**Case No. 2006.1073E**

# **THE EXPLORATORIUM RELOCATION PROJECT**

## **COMMENTS AND RESPONSES**

**DATE:** June 25, 2009  
**TO:** Members of the Planning Commission and Interested Parties  
**FROM:** Bill Wycko, Environmental Review Officer  
**RE:** Case No. 2006.1073E, Exploratorium Relocation Project  
Comments and Responses on the DEIR

THE EXPLORATORIUM RELOCATION PROJECT  
FIGURE C&R 13 (NEW DEIR FIGURE III.C-8): VIEWPOINT 7 - VIEW WEST FROM SAN FRANCISCO BAY

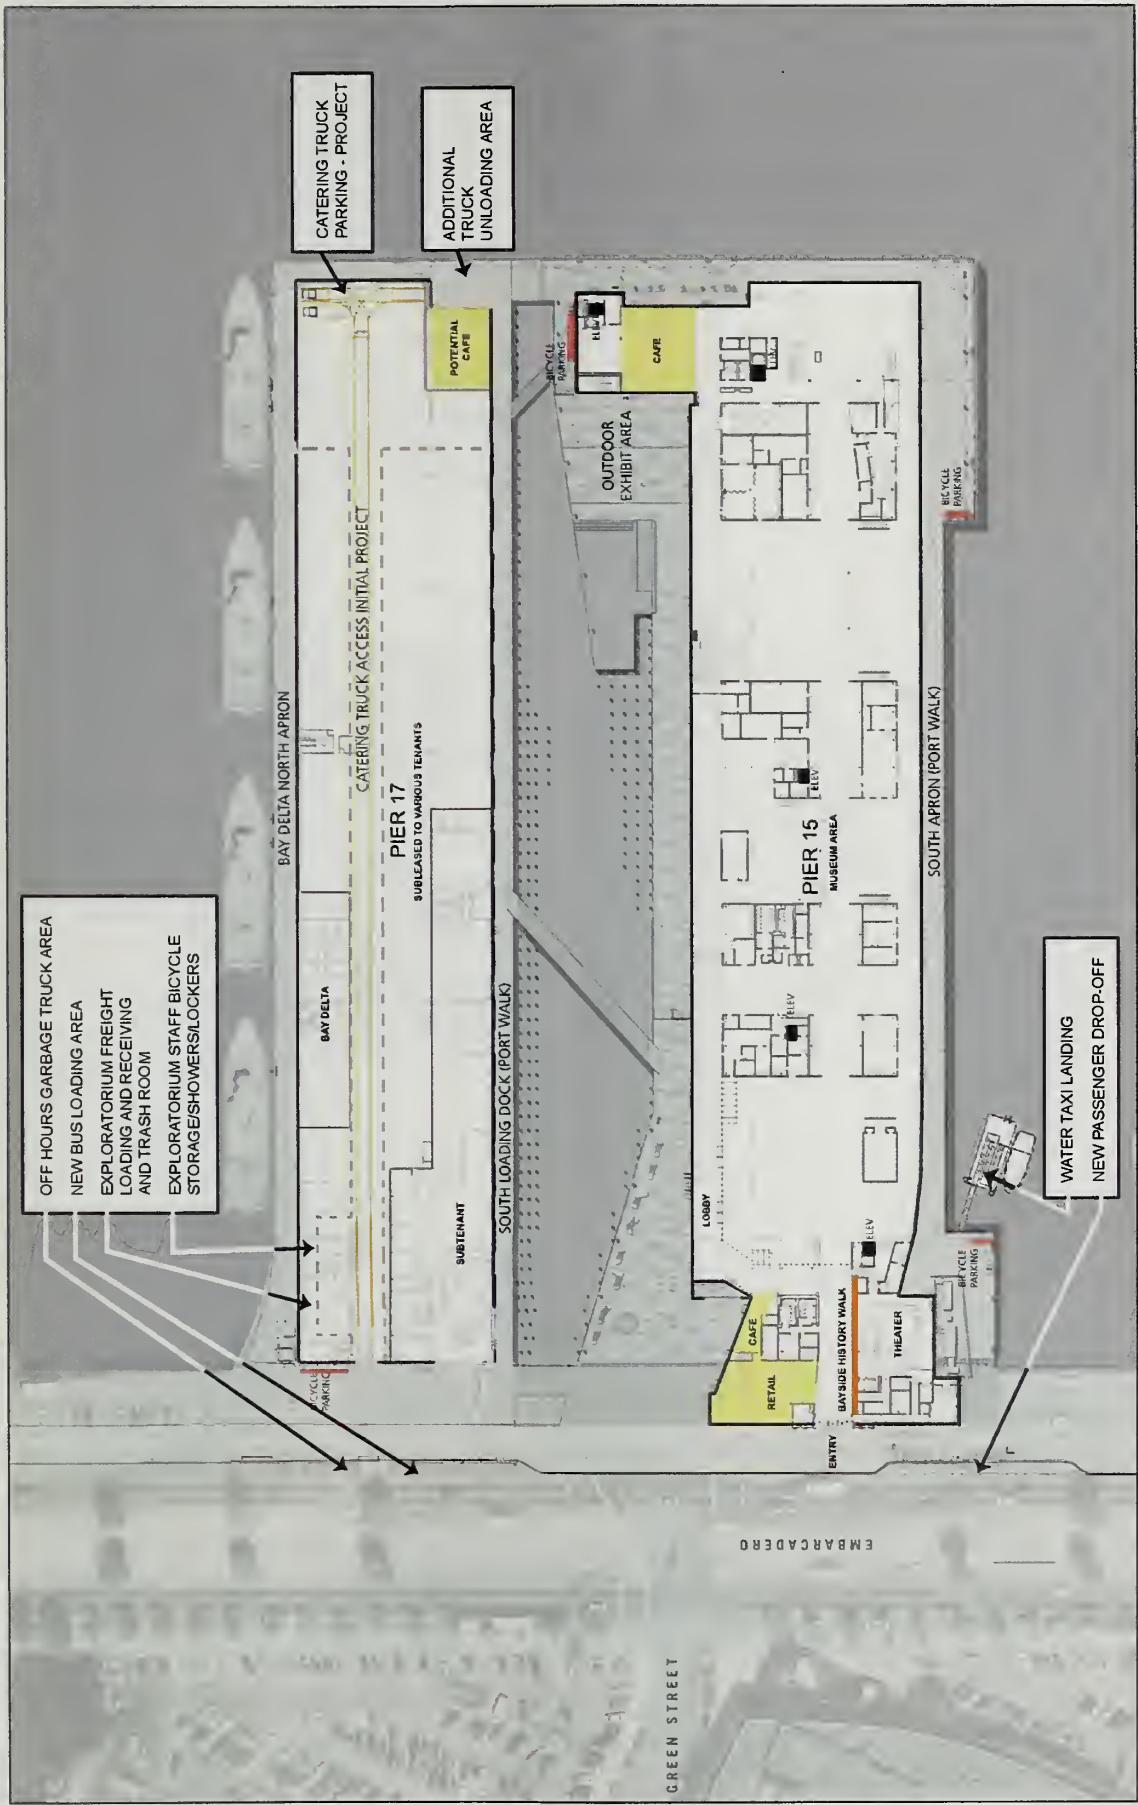
Just to comment, I think the DEIR itself is woefully inadequate in terms of its graphics. How we can make a conclusion that the connector building is sort of okay and arrive at some mitigation measures, at least on what's on the published document, I don't see how we can reach those conclusions. And perhaps some better graphics would assist the public in doing so. (*Commissioner Sugaya, March 5, 2009*)

Figure III.C-8, illustrates the view of the Project Site from a location on the San Francisco Bay to the northeast of the Project Site. The most prominent change in this view resulting from the Project would be the replacement of the existing Connector Building with the new Bridge Building. The north and east façades of the Bridge Building would be fully visible. Improvements to the east and north façades of the Pier 15 Shed also would be visible, along with improvements to the east aprons of Piers 15 and 17. Several structures along the east edge of the Financial District would also be more visible.

Under the Expanded Project, the most prominent change in views would be the rehabilitation of the north, south and east façades of the Pier 17 Shed structure, as well as improvements to the south loading dock of Pier 17.

THE EXPLORATORIUM RELOCATION PROJECT  
**FIGURE C&R 3: PROJECT SITE PLAN GROUND FLOOR**

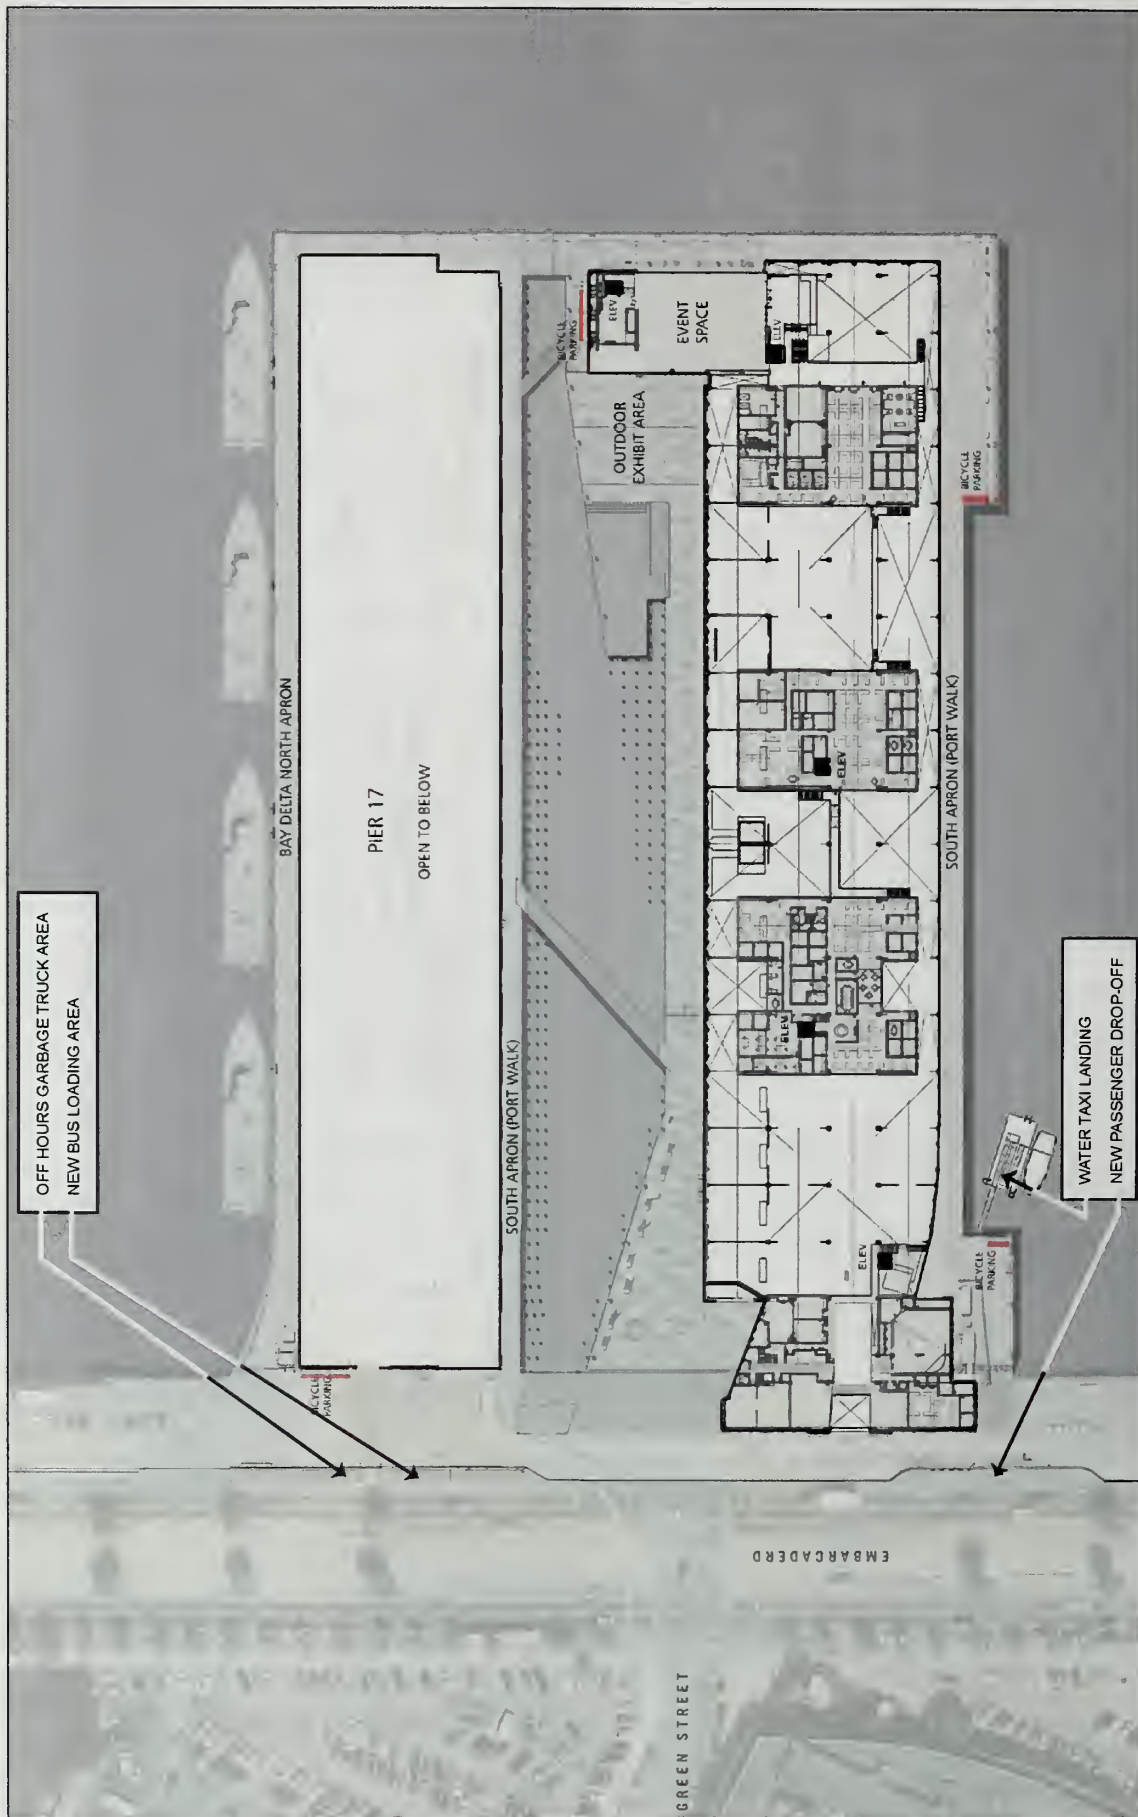
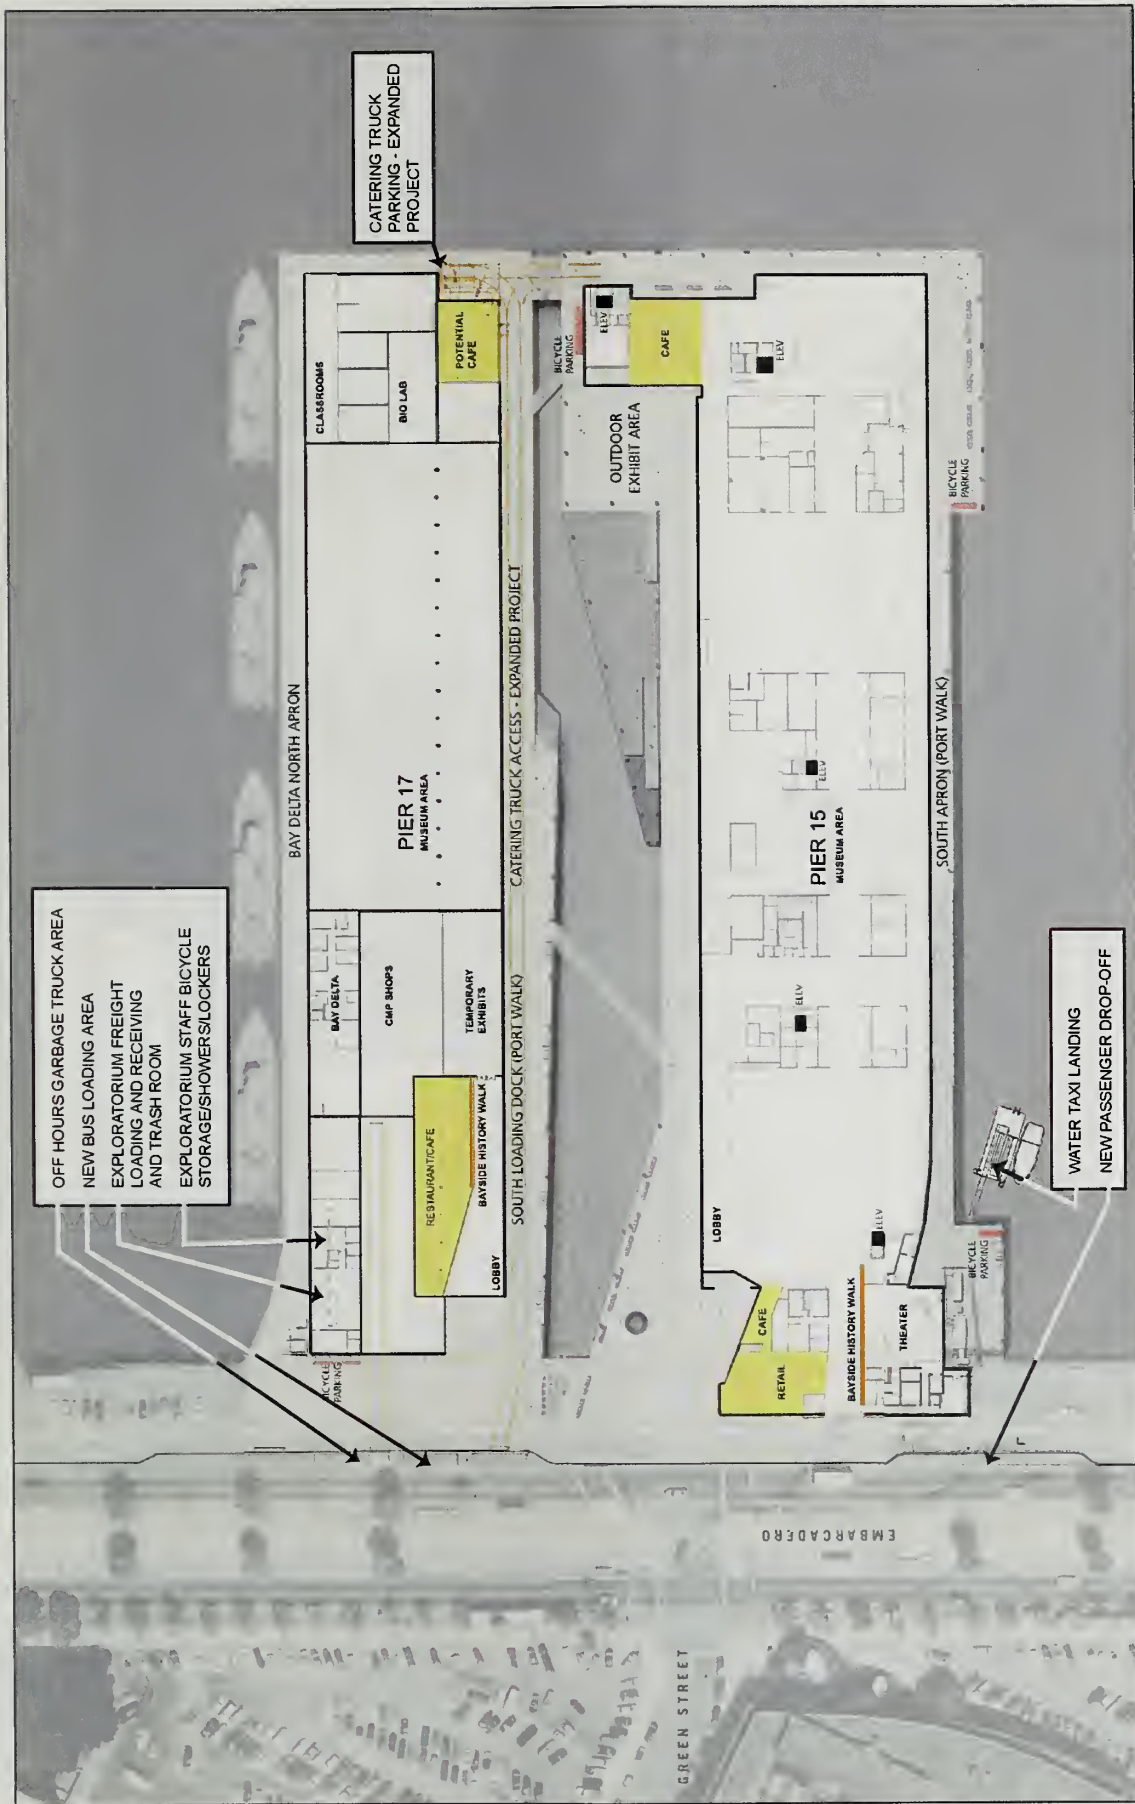
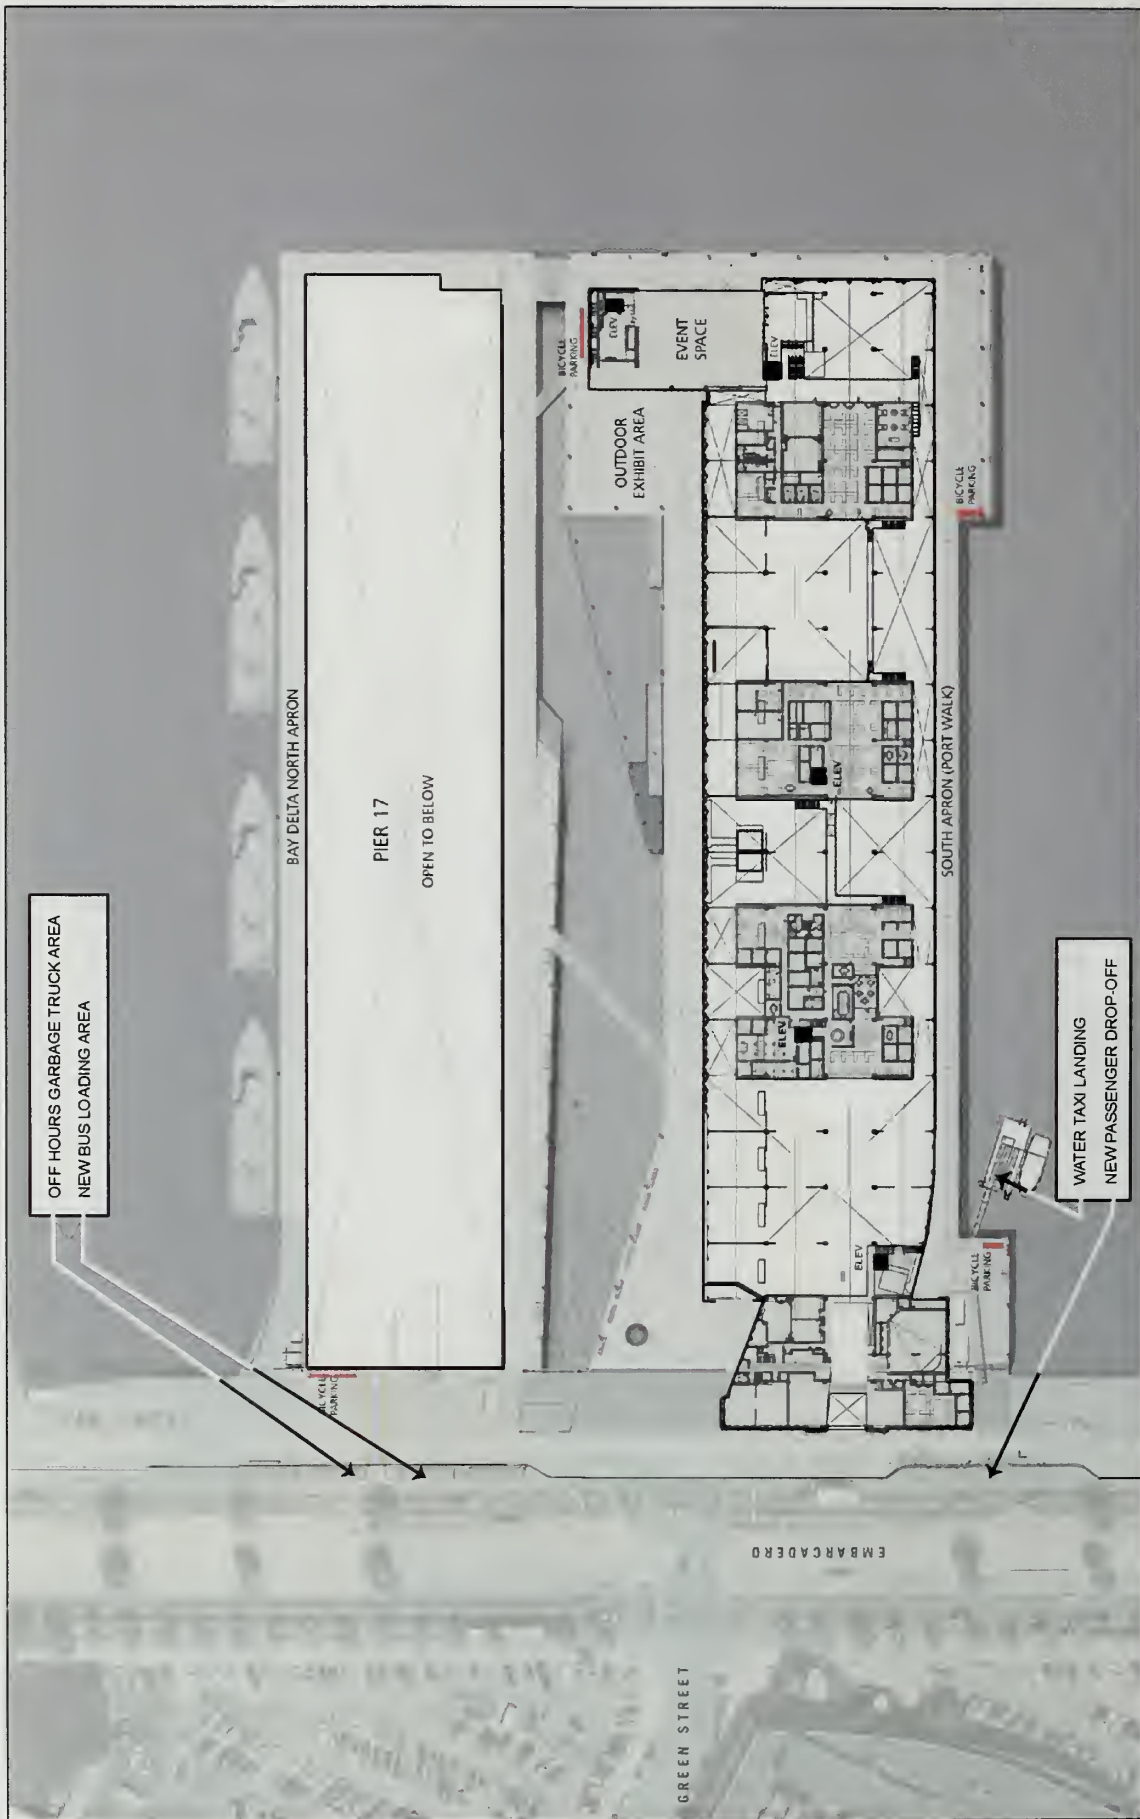
The proposed new Bridge Building is not adequately depicted nor fully described in the DEIR. The Draft EIR fails to adequately describe and depict the proposed new Bridge Building. There are no detailed drawings of this proposed new structure in the DEIR clearly showing the materials, architectural details or scaled height measurements in comparison to the existing historic sheds. The elevations are so pale as to not be readable (Figure 5) or they specifically state that the elevations are “not to scale” (Figure II-15). The photomontages contained at III.C-15 do not adequately show the proposed new Bridge Building and, because of the wide-angle lenses used for the basic image, these images are misleading and not at all informative. This appears to be a serious inadequacy of the DEIR. Without separate detailed presentations, there is no way the public or decision-makers could understand the potential impacts that the design of this building could have on historic resources and the aesthetics of our Waterfront. (*Vedica Puri, Telegraph Hill Dwellers, February 25, 2009*)

For the proposed new bridge building, there are no detailed drawings in the DEIR which clearly show the architectural detail or scaled height measurements in comparison to proposed sheds. (*Andy Katz, March 5, 2009*)

The commentors believe that the DEIR does not contain adequate graphics that accurately depict components of the Project and Expanded Project. The Project Description graphics have been revised to present details of the Project and Expanded Project more clearly. Additional graphics have also been included to illustrate the floor plans and building elevations for the Project and Expanded Project. The revised Project Description graphics are presented in Figures C&R-3 through C&R-10 on pp. C&R-35 through C&R-45 of this Comments and Responses document. These Figures will replace Figure II-3 through II-5 of the DEIR. Additional simulations of the Project and Expanded Project have been prepared to depict the Bridge Building as viewed from Herb Caen Way and the San Francisco Bay. Figure C&R-11, p. C&R-47 illustrates the locations of the new viewpoints and replaces Figure III.C-1, p. III.C-4 of the DEIR.
